CITY OF ROCHESTER, NEW YORK

PORTLAND AVENUE REVITALIZATION

FROM LUX STREET TO NORTON STREET

90% PLANS
APRIL 16, 2014

SAFE SCHOOL ROUTE WITHIN PROJECT AREA - SCHOOL #36
NOT TO SCALE

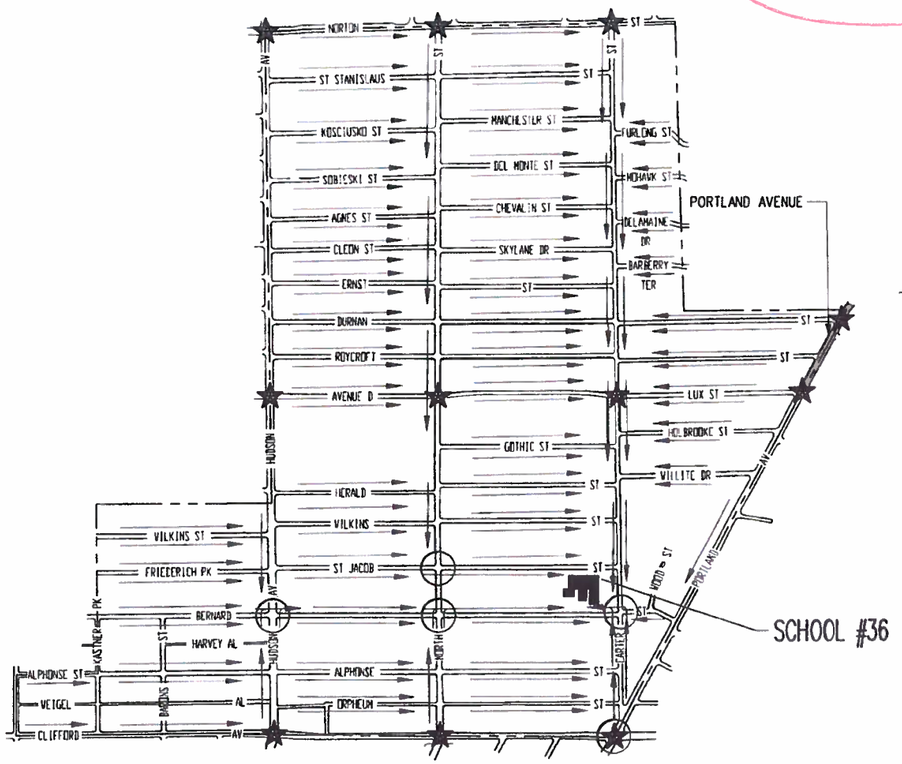
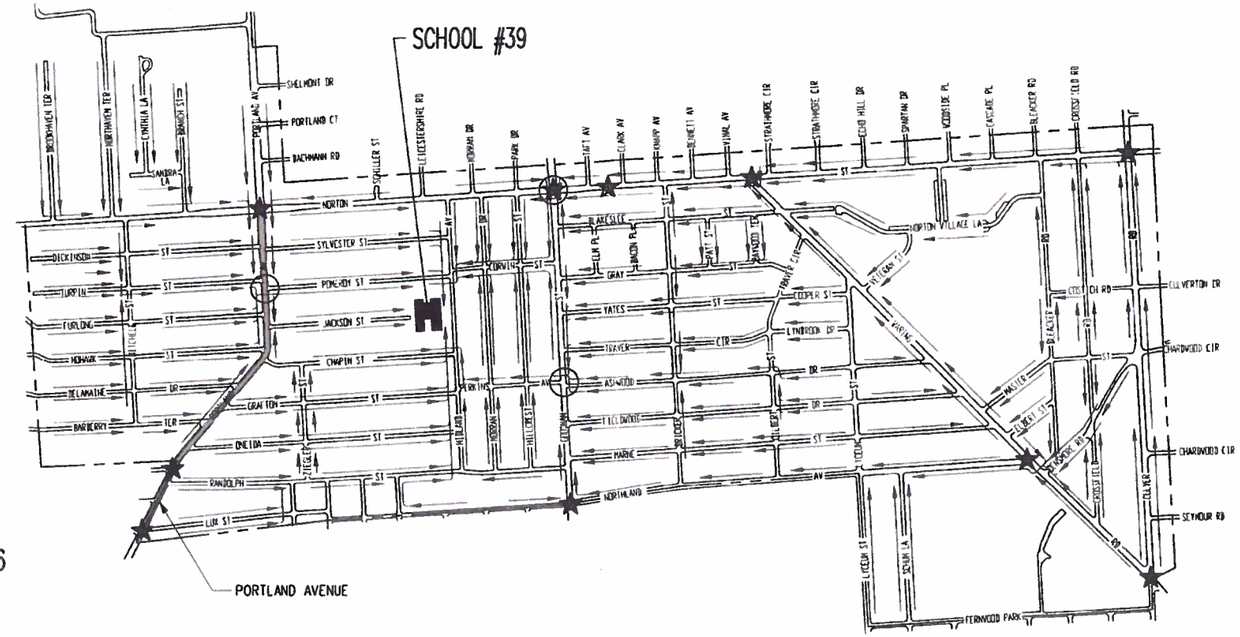
Show North arrow

DRAWING NO.
GS-1

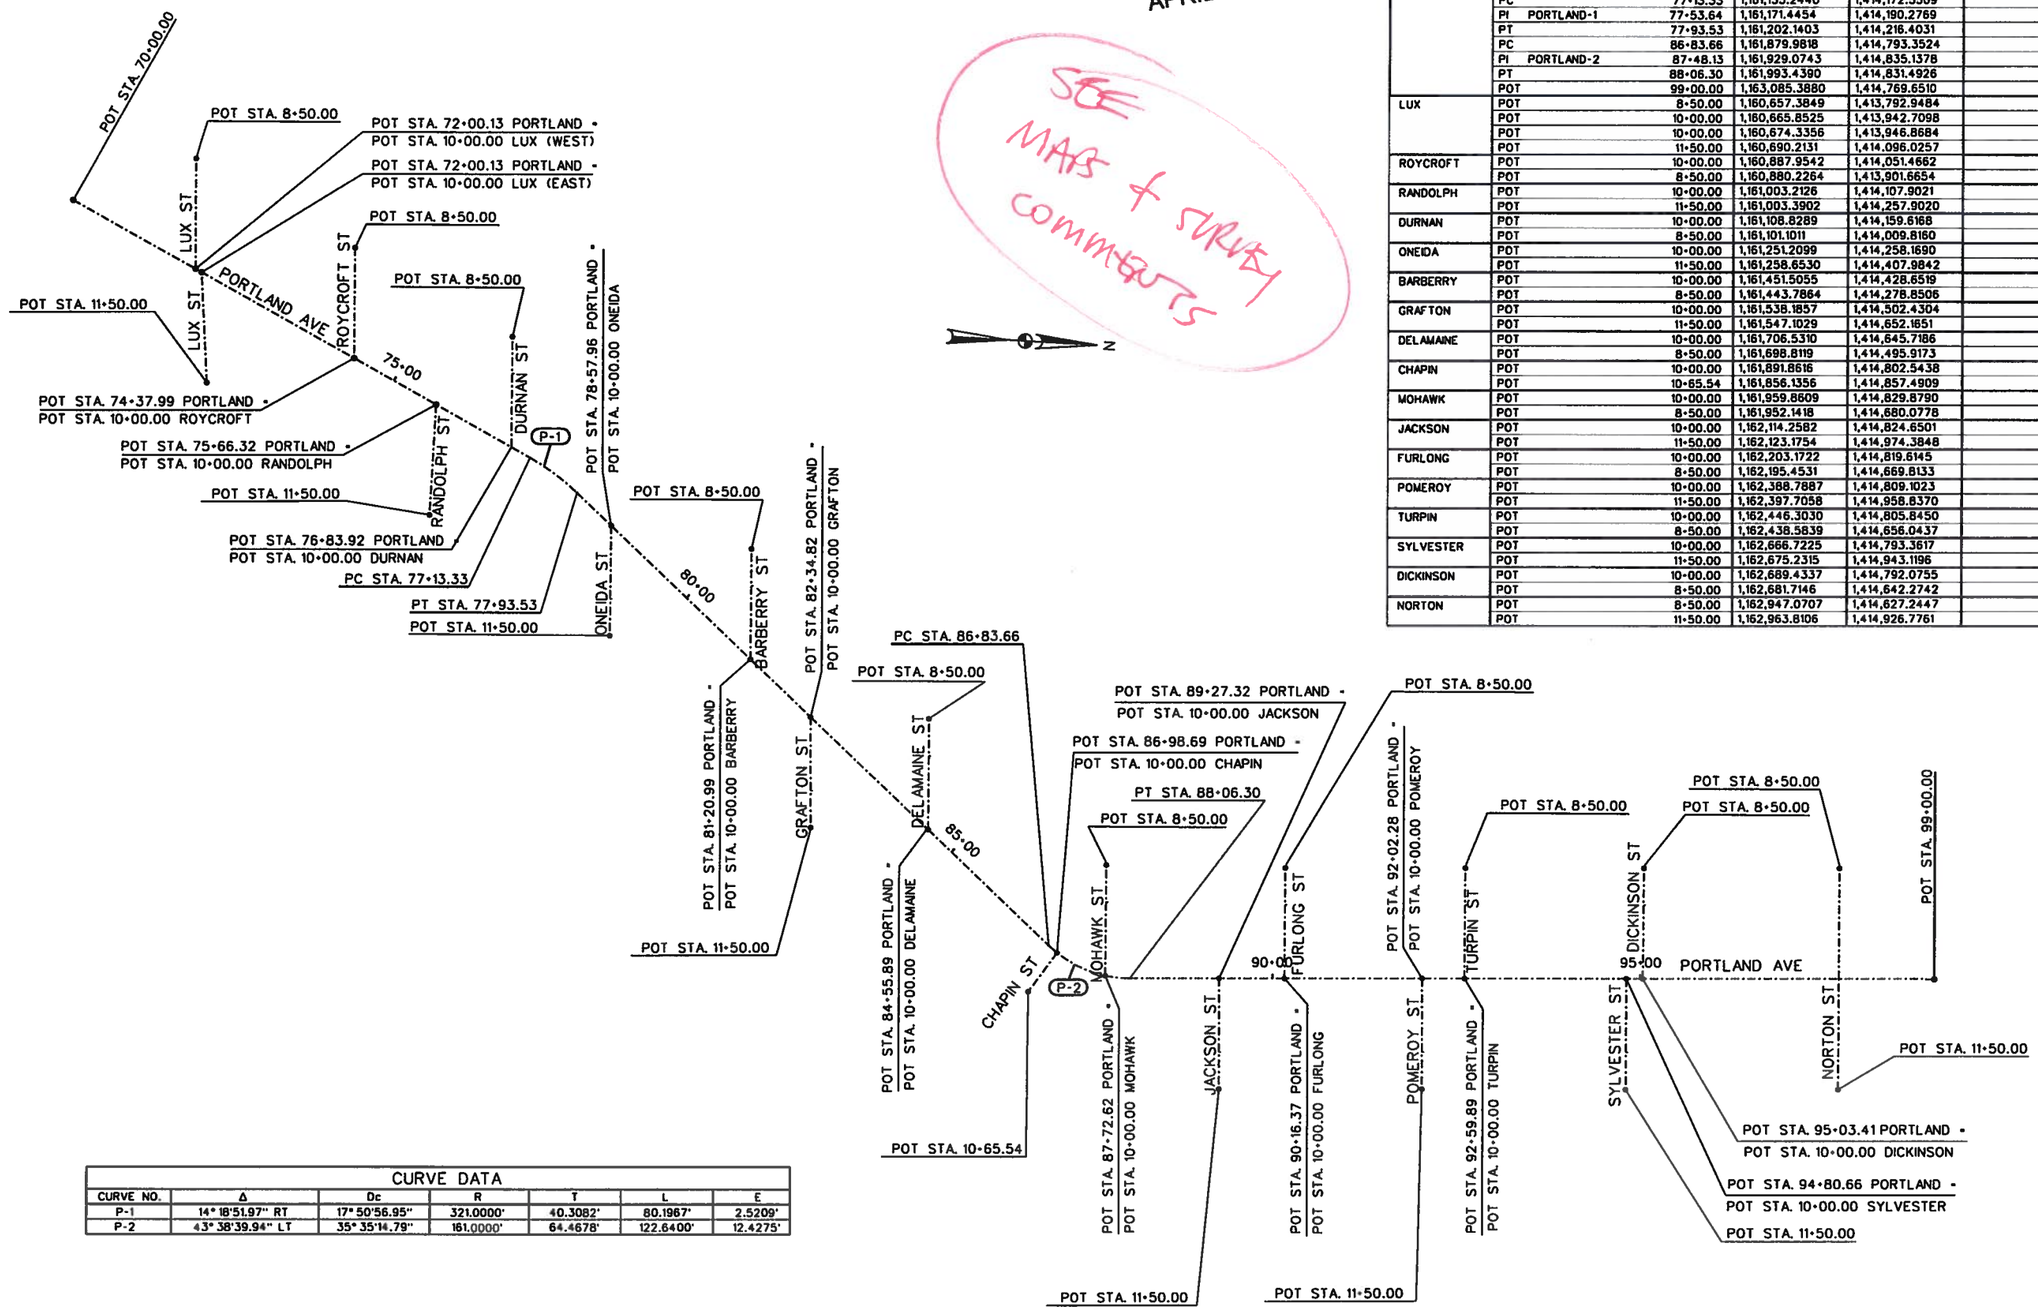
SEE MAPS & SURVEY COMMENTS

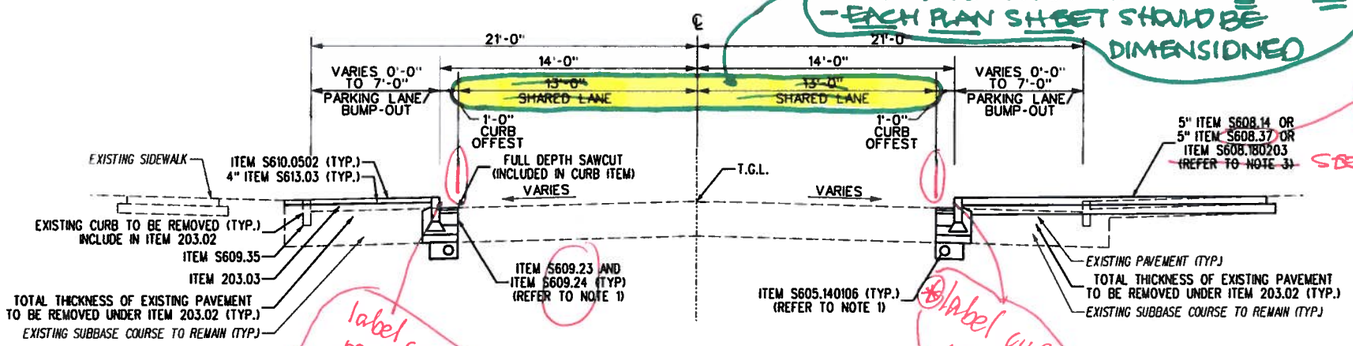
(*) SHOW STRIPING DIMENSIONS ON THE PLAN SHEETS - NOT HERE - EACH PLAN SHEET SHOULD BE DIMENSIONED — Typical

exposed aggregate only on walks not apron (ok as is)

PARTIAL PLAN 1 — 20 / CD-7

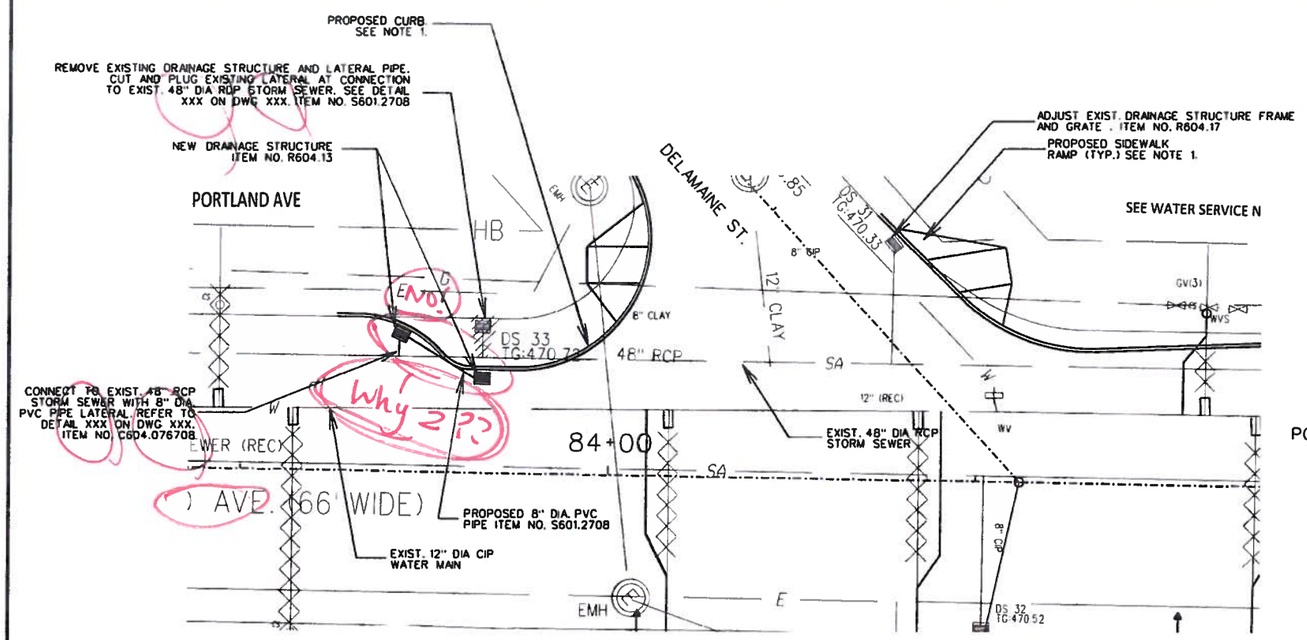
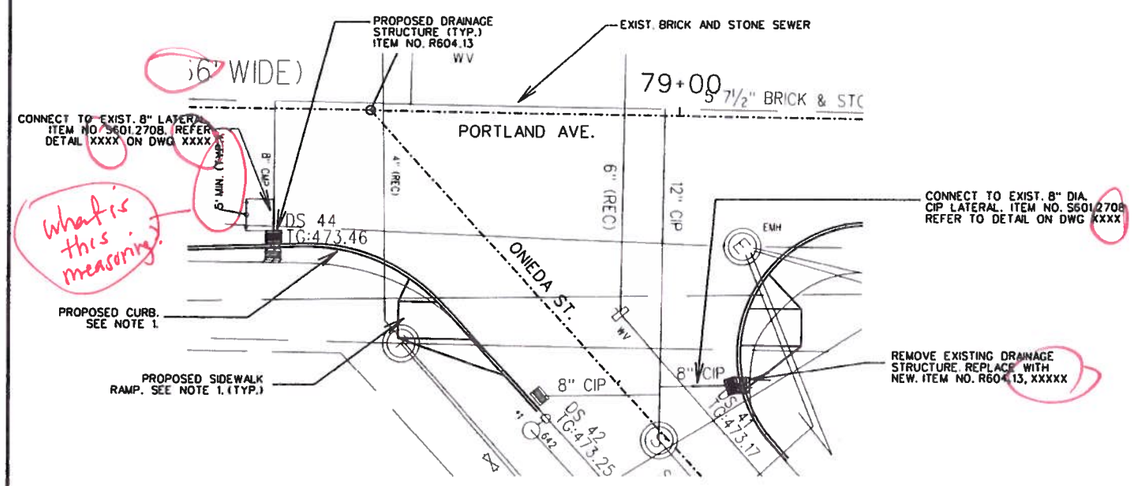
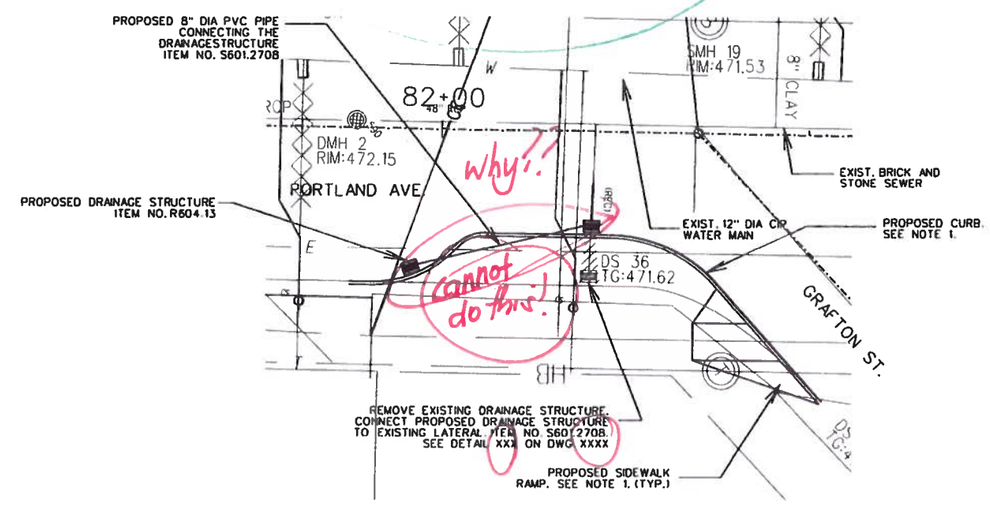
Need more info from County Pure Waters these designs are ok!

CONCRETE BUS SHELTER PAD

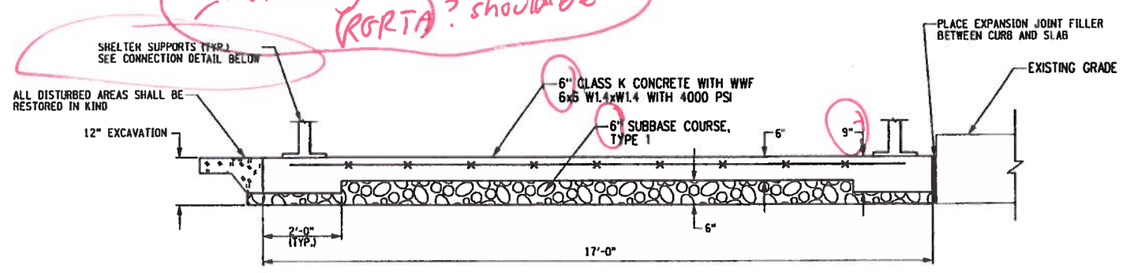
ins talled by others? (RGRTA)? should be

INTERSECTION BUMP-OUT DETAIL
NOT TO SCALE

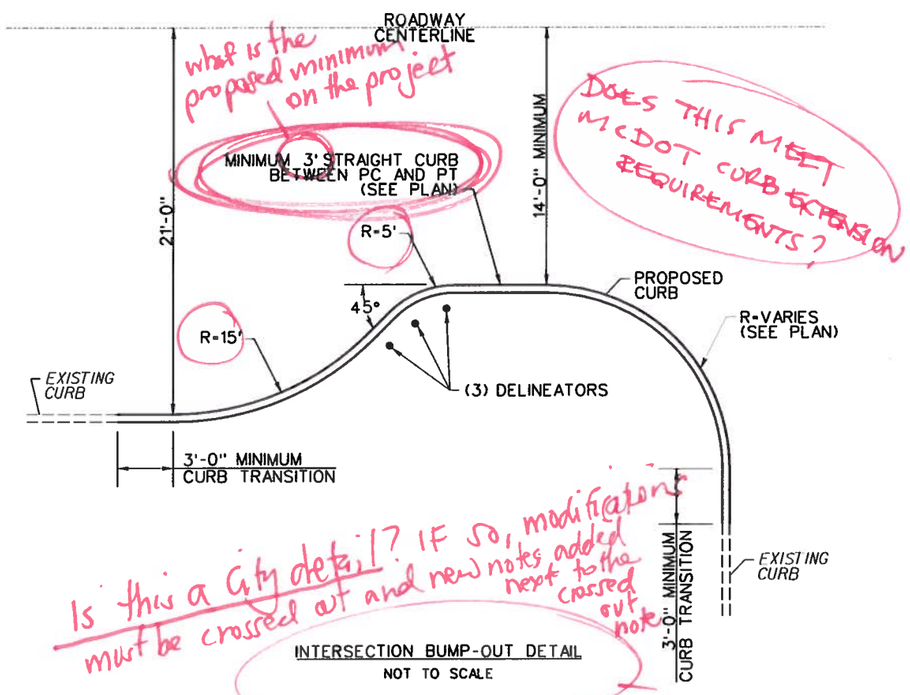
Is this a City detail? IF SO, modifications must be crossed out and new notes added next to the crossed out note?

1025 PORTLAND AVENUE
DRIVEWAY LAYOUT
NOT TO SCALE

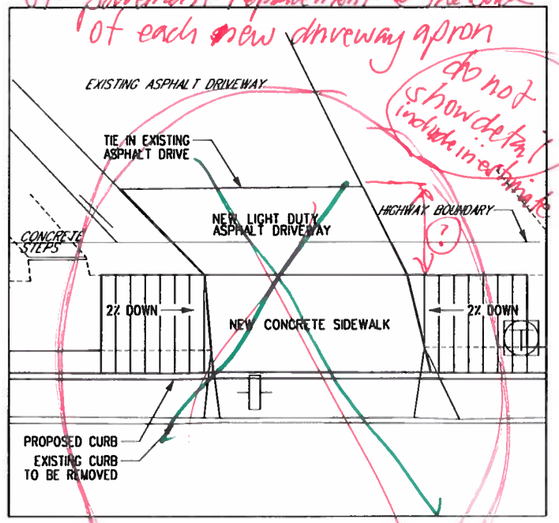
do not show detail include in estimate

DECORATIVE CROSSWALK DETAIL (BY OTHERS)

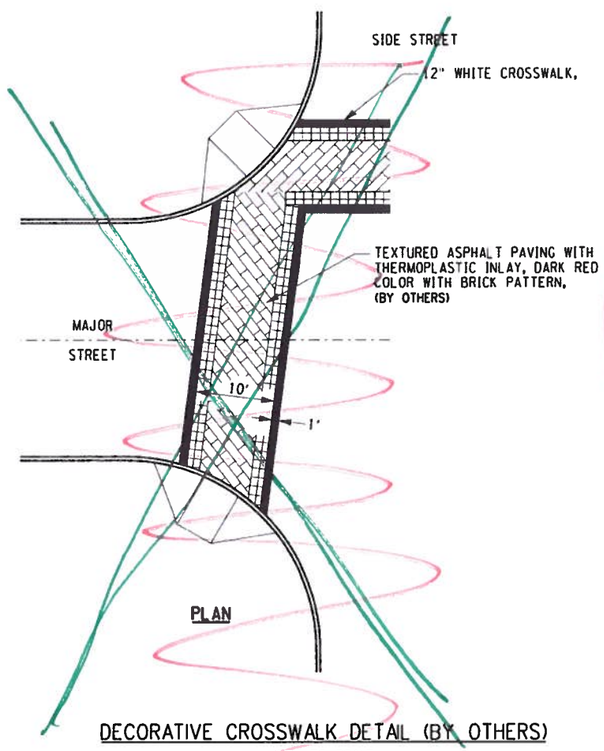
yes – to be used on all crossings for this project – MTR will install decorative crossings

DRAWING NO.
PL-2
SHEET 35 OF 47
KCI JOB NUMBER
22134062

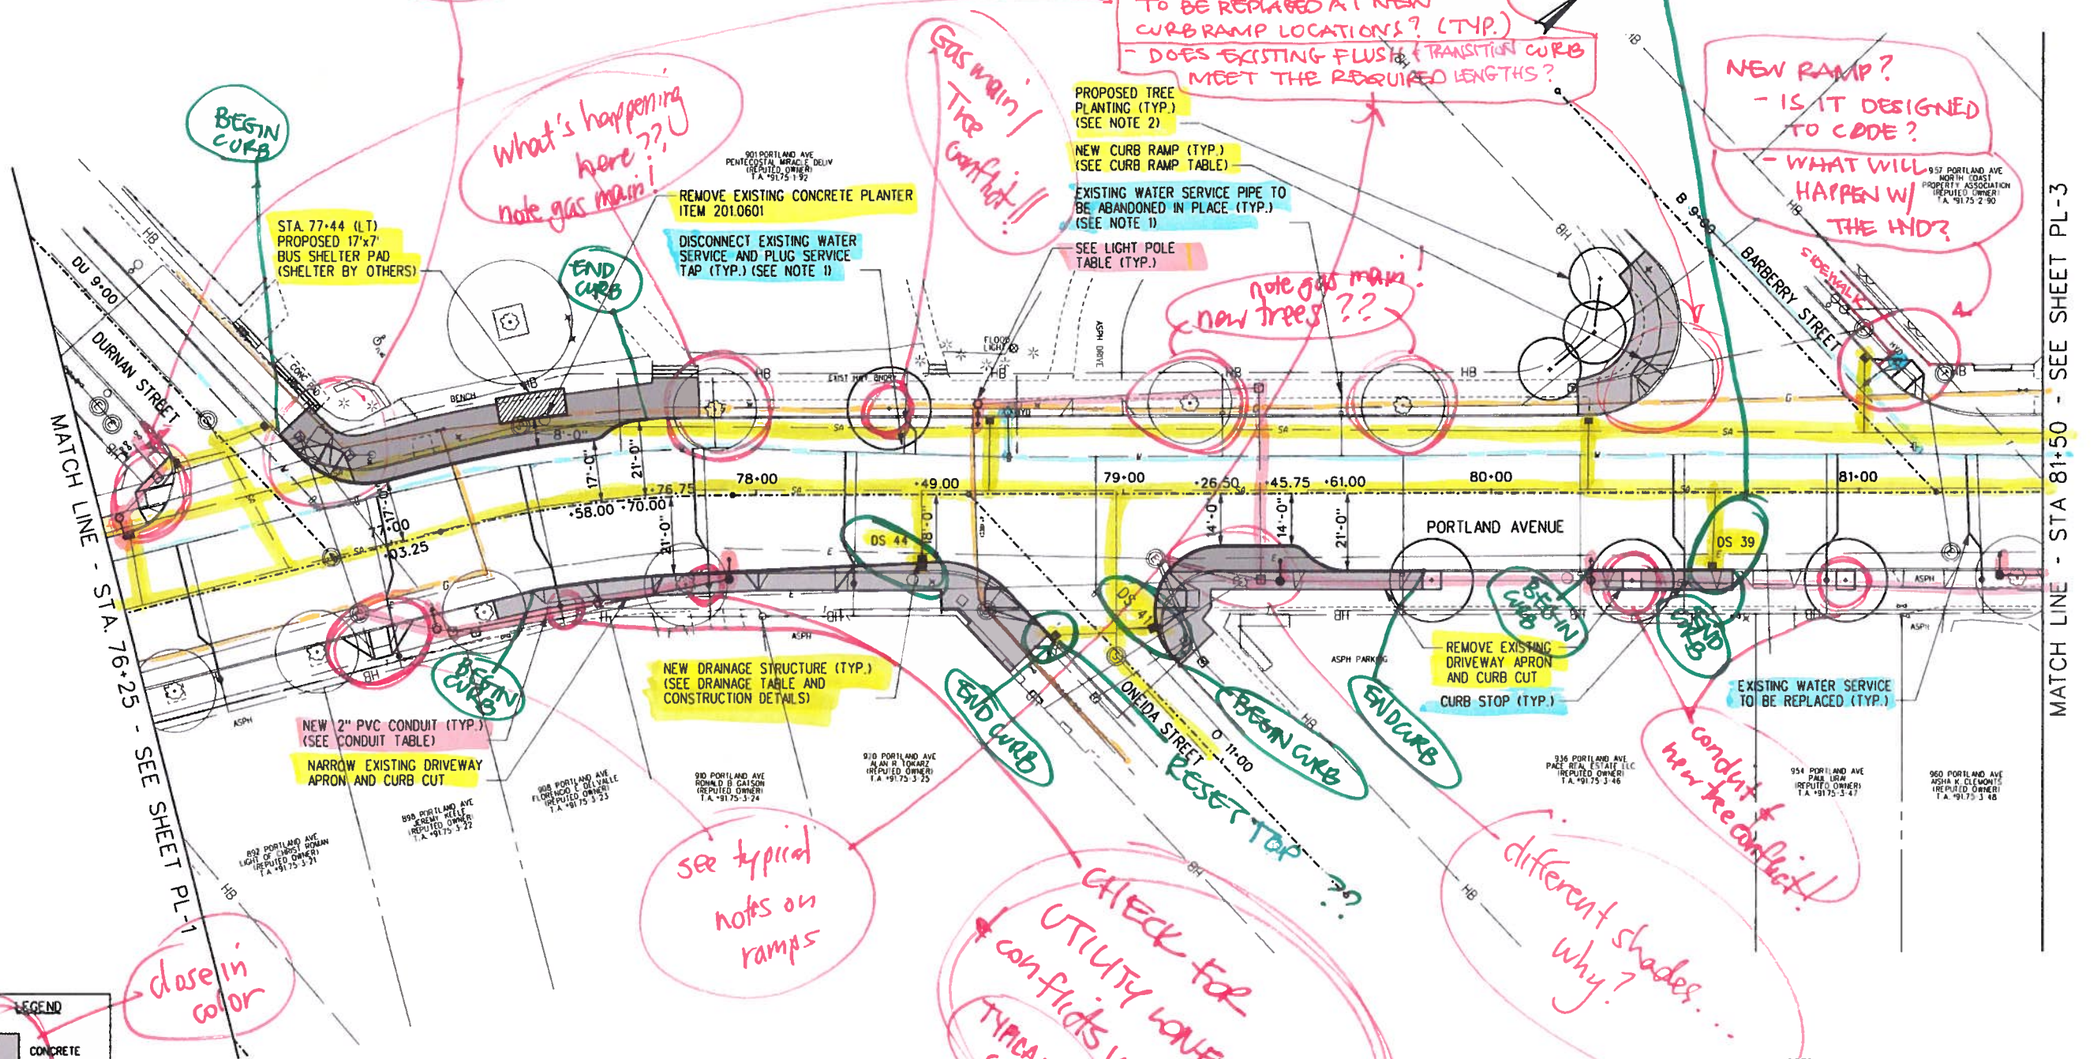
TYPICAL FOR ALL MEN RAMPS!
- DOES CURB NEED TO BE REPLACED AT NEW CURB RAMP LOCATIONS? (TYP.)
- DOES EXISTING FLUSH & TRANSITION CURB MEET THE REQUIRED LENGTHS?

NEW RAMP?
- IS IT DESIGNED TO CODE?
- WHAT WILL HAPPEN W/ THE HYD?
